**MOUNT OWEN CONTINUED
OPERATIONS PROJECT**

Response to Submissions

REPORT A:
NSW Agency and Community Submissions

June 2015

FIGURE 4.6

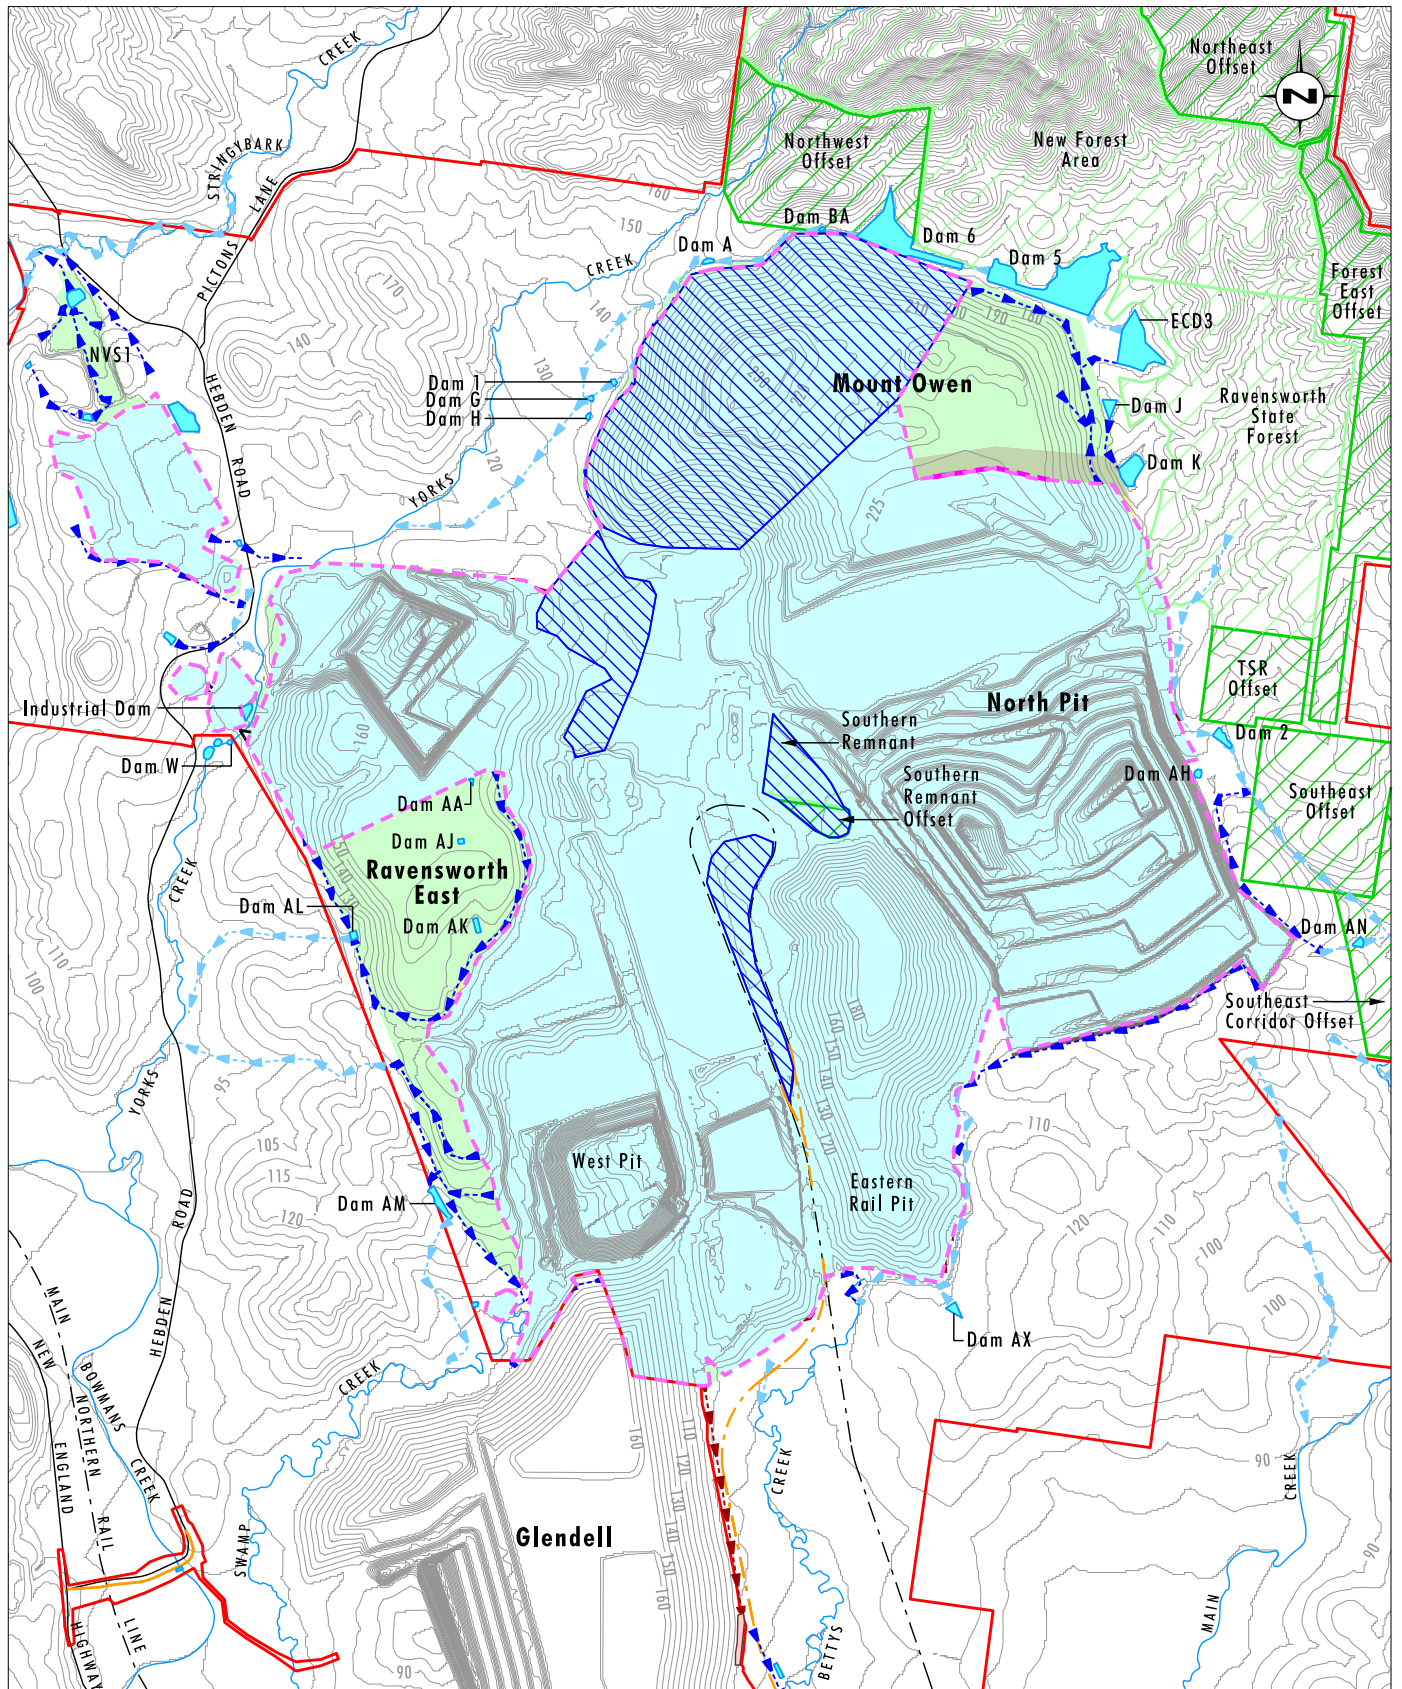
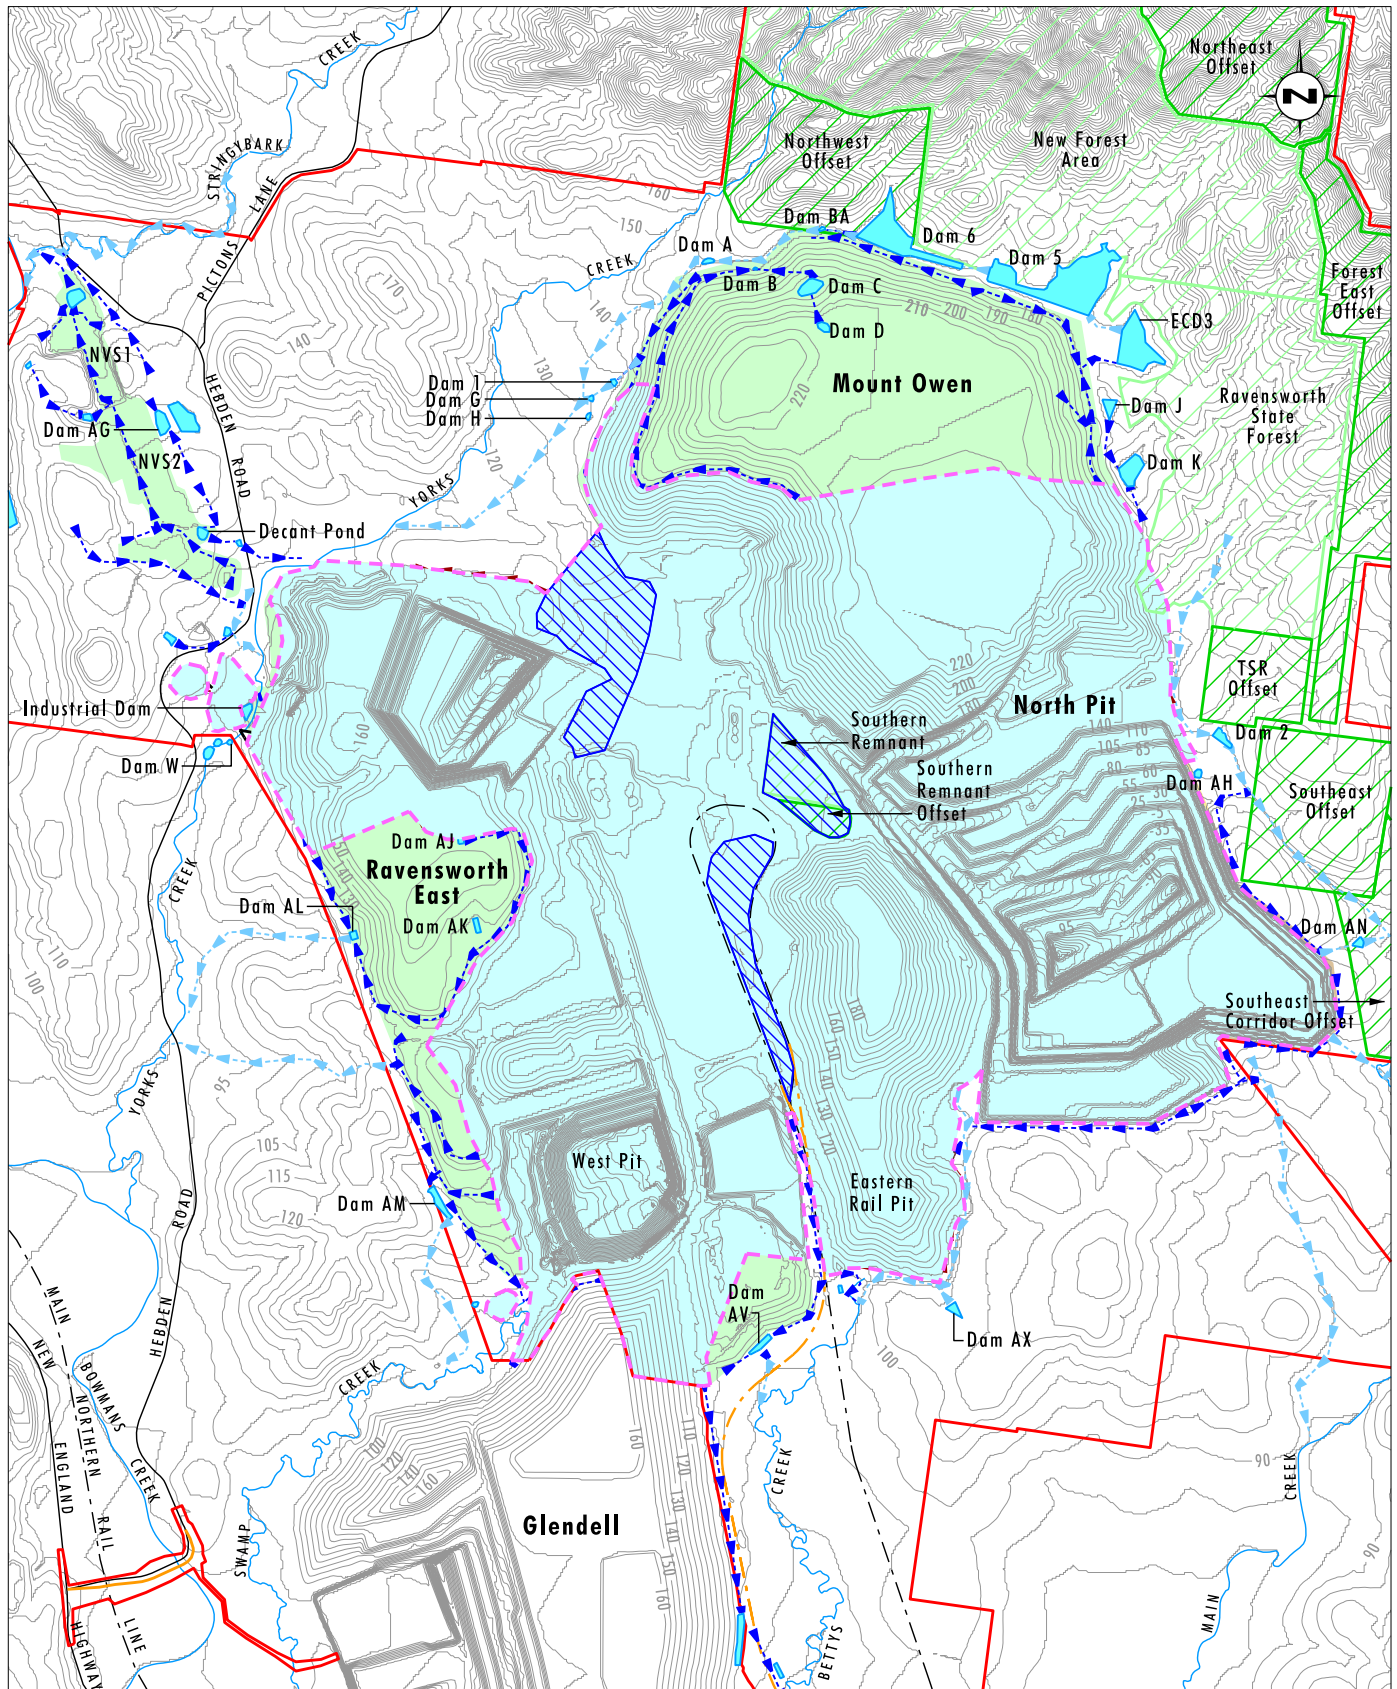
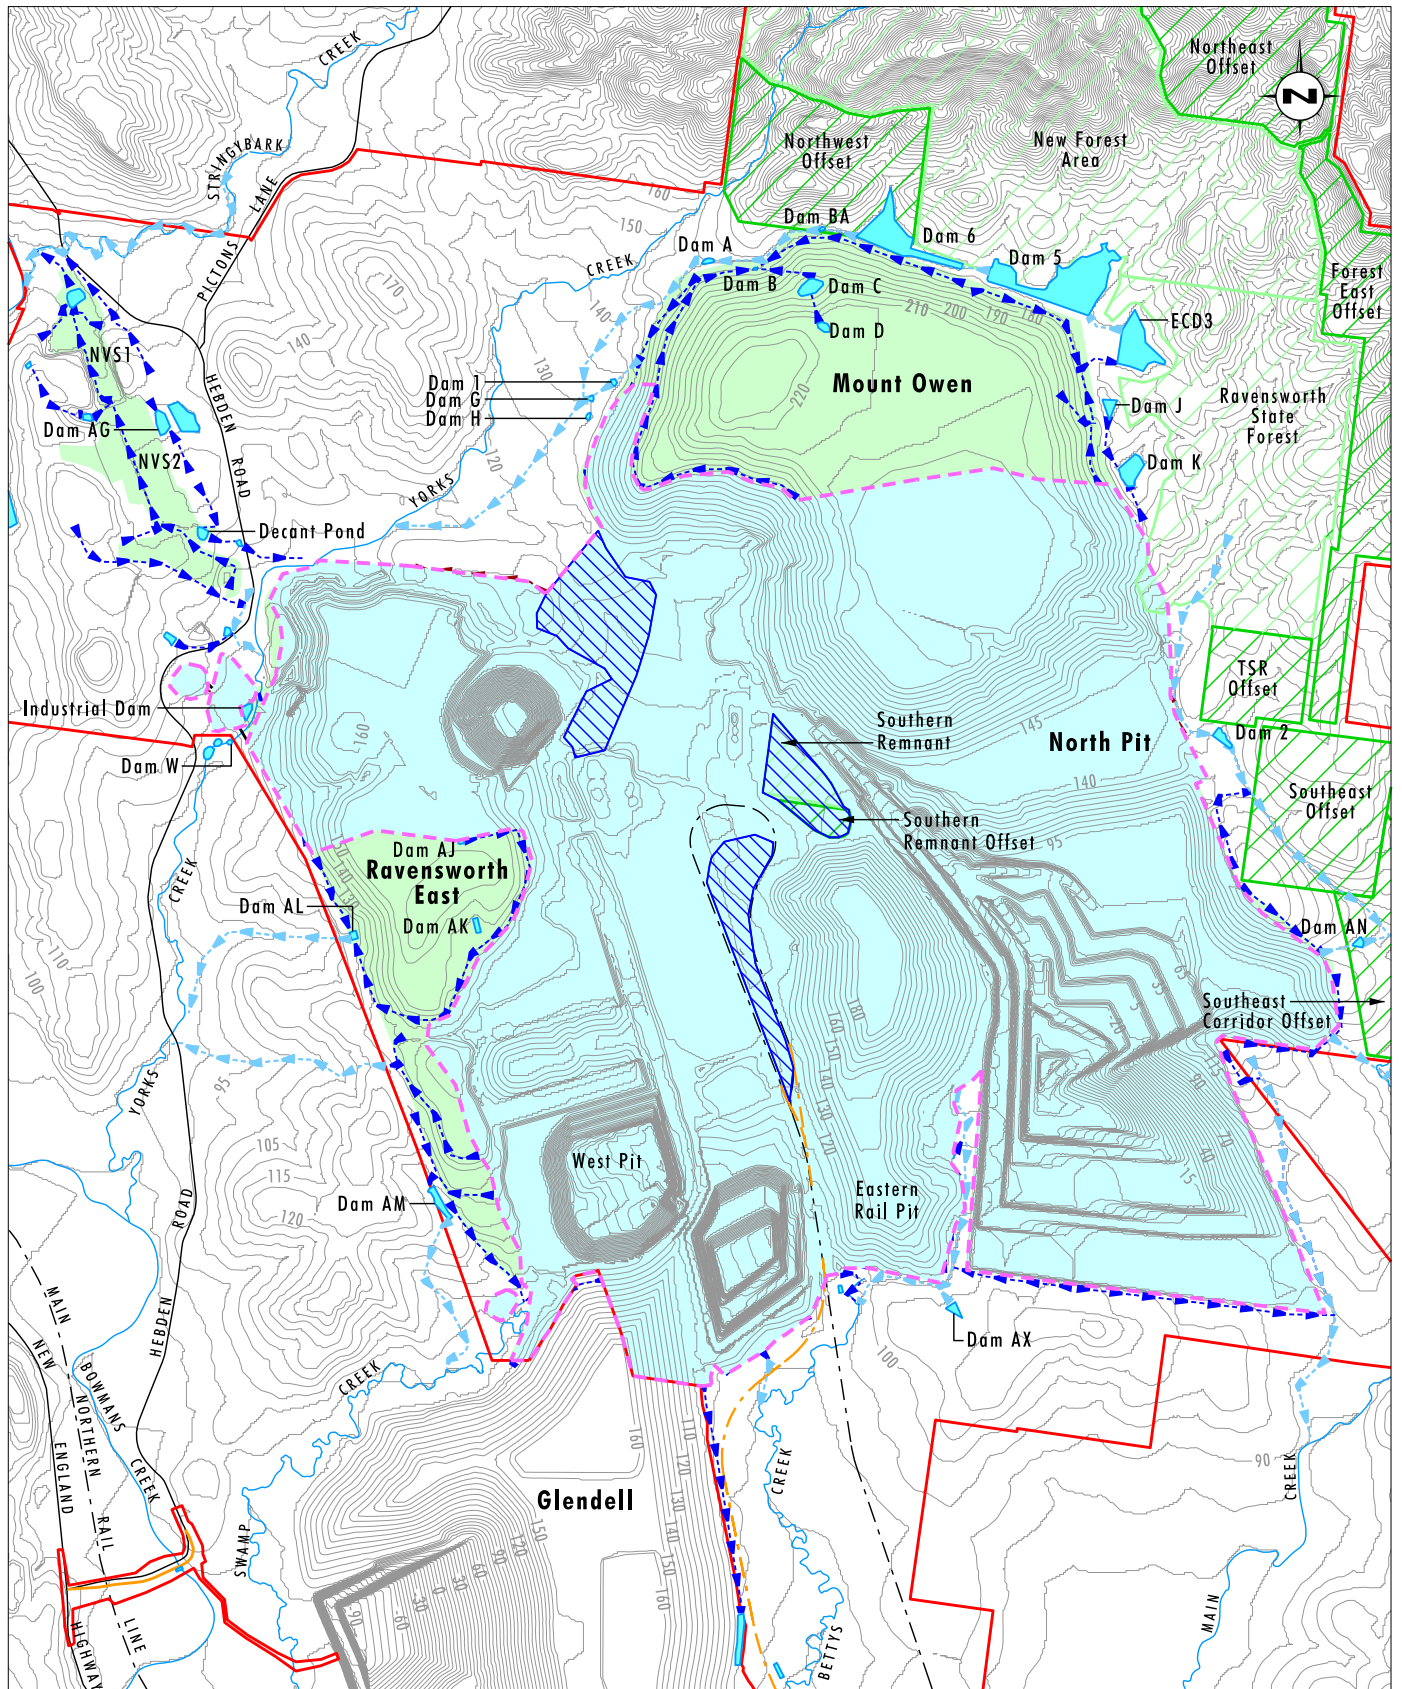
Figures 4.1-4.5 (from the EIS) show the conceptual surface water management of the site, including clean, dirty and mine water flow paths. Office of Water requires a flow chart or schematic to show more clearly the exact flow paths of water onsite at different stages of the mine's life in order to ensure the clean water diversion system is efficient and all clean water is accounted for or licensed appropriately. For example, it appears from the figures that clean water will be diverted into the "Rail Loop Dam" at years 1, 5 and 10, which appears to be a mine water dam. Further information and a document showing the flow paths more clearly is required to further assess the clean water management system and any associated licensing requirements.

Office of water requires more information as to whether harvestable rights provisions are being utilised to account for the interception or use of clean water onsite or otherwise how any interception of clean water that is not diverted is to be accounted for.

Figures 4.6 to 4.8 show the extent of the water management system based on the conceptual mine plans for Years 1, 5 and 10 of the Project. These figures also show the existing and proposed clean water diversions for the Project and identify undisturbed areas where clean water runoff will be captured during each stage. This includes an area during Year 1 of the Project that is rehabilitated clean catchment with clean water runoff that will be captured during Year 1 of the Project. The areas identified as clean water runoff capture are approximately 277.5 hectares in Year 1, reducing to approximately 71.6 hectares in Years 5 and 10. Based on 100 per cent capture of runoff at the regional runoff rates (refer to www.farmdamscalculator.dnr.nsw.gov.au) of 0.7 ML/hectare/year, this equates to capture of approximately 194 ML during Year 1 and approximately 50 ML during Years 5 and 10. Based on Mount Owen landholdings of approximately 4,913 hectares, Mount Owen has a harvestable rights provision of approximately 344 ML/year (i.e. 4913 ha x 0.7 ML/ha/yr x 10% harvestable rights provision). As such, the capture of clean water runoff (as outlined above and shown on the **Figures 4.6 to 4.8**) is within the harvestable rights provisions of Mount Owen.

FIGURE 4.10

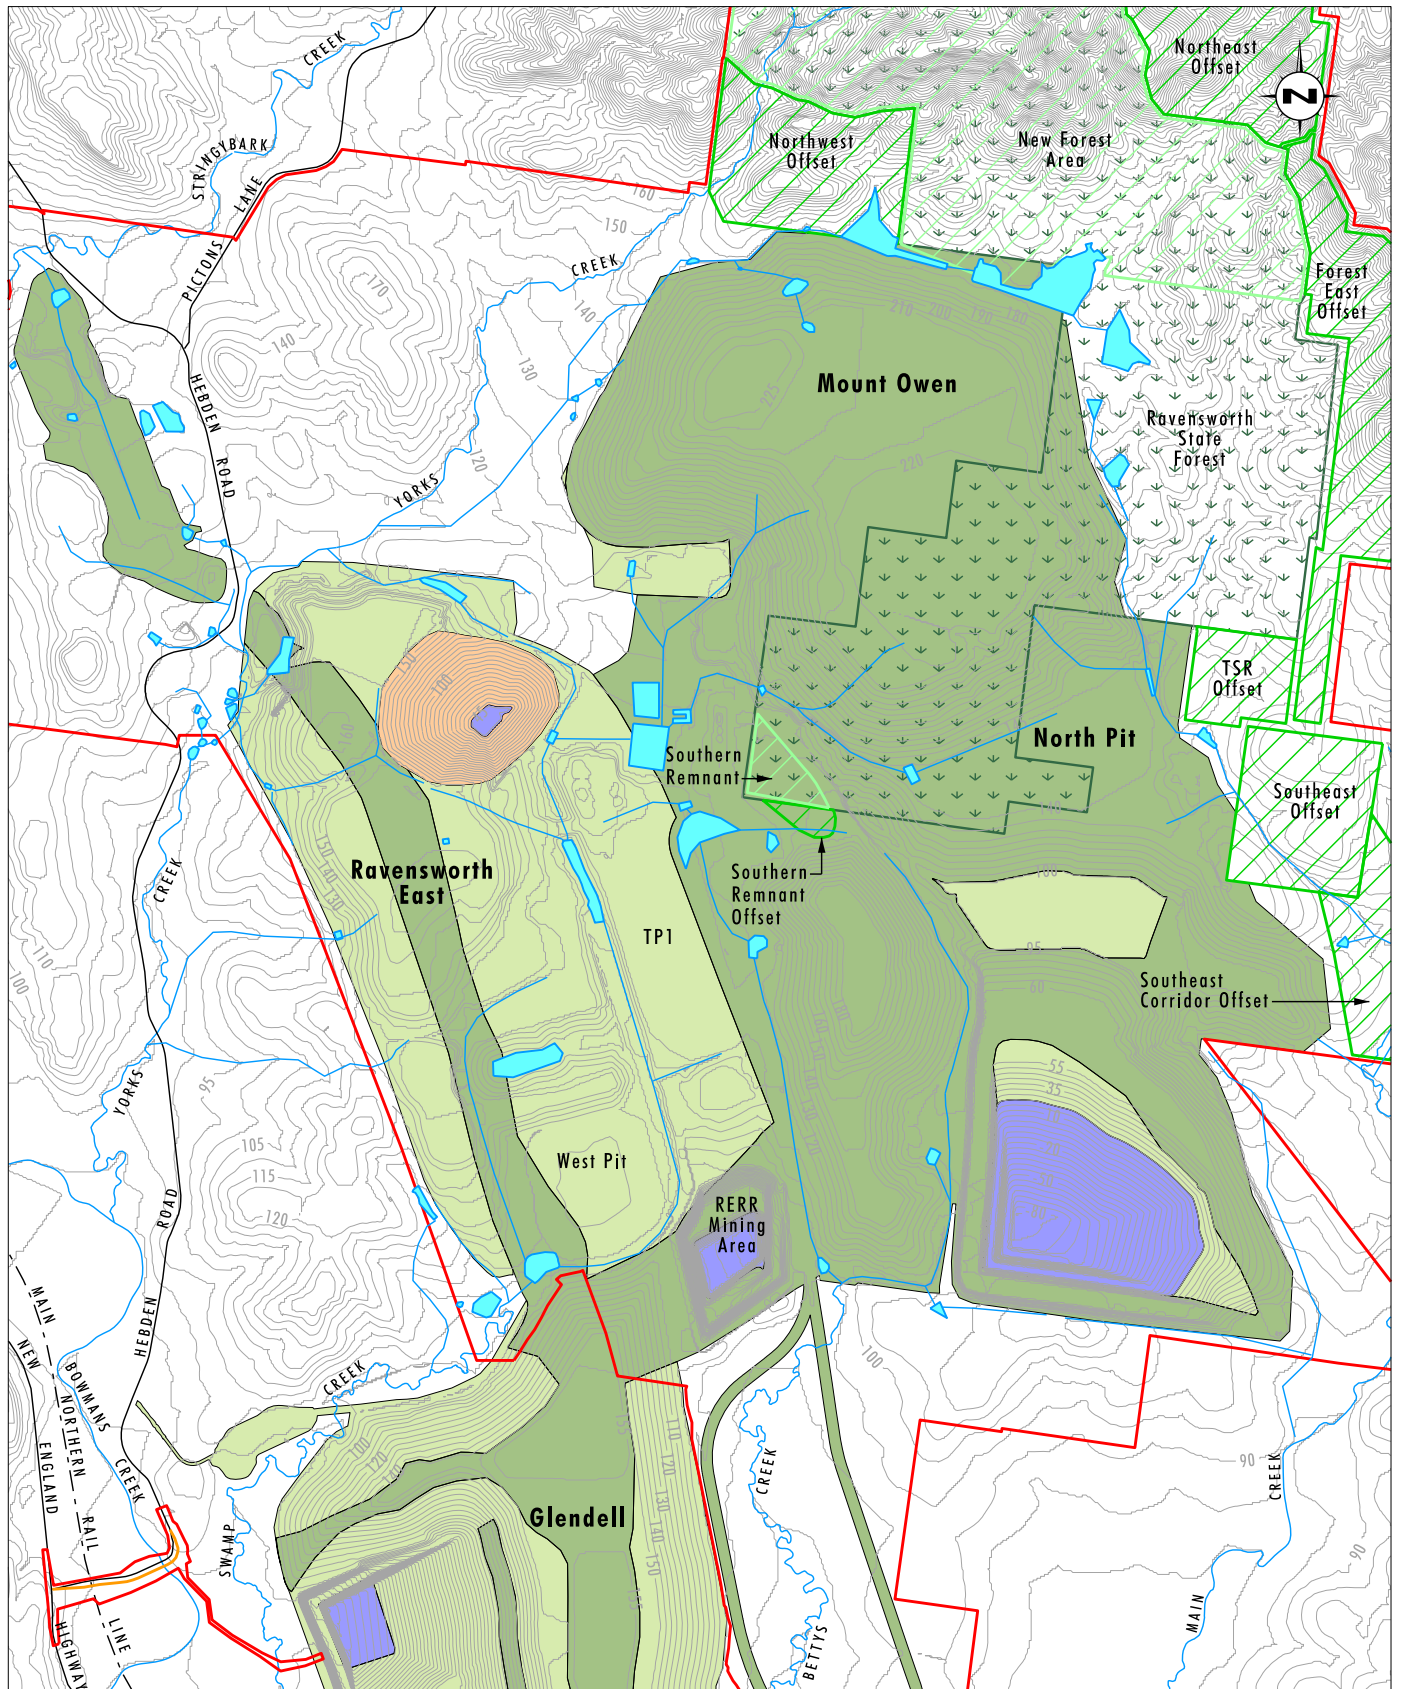
Office of water requires further information on the design of the final landform, with consideration of the hydrological, geomorphic and ecological function of the landform. The proposed landform and final surface water management system (Figure 4.5, Surface Water Assessment) shows an extensive network of drains that do not replicate natural drainage or geomorphic patterns (for example drains close together running in opposite directions). Comment is sought on how natural hydrological and geomorphic conditions will be considered in the design of the final landform.

Figure 4.10 shows the likely drainage lines in the indicative final landform. The Conceptual Closure Plan developed for the Project will include further consideration of natural hydrological and geomorphic conditions in the development of drainage lines. The MOPs developed for the operations will include further detail on the drainage in parts of the rehabilitated landform that will be returned to the surrounding clean catchments. The Detailed Closure Plan for the Project developed within 5 years of proposed closure, will include greater detail on drainage in the final landform. This Plan will be developed having regard to the experience in the management of drainage in the landform of the Mount Owen Operations and natural hydrological and geomorphic conditions.
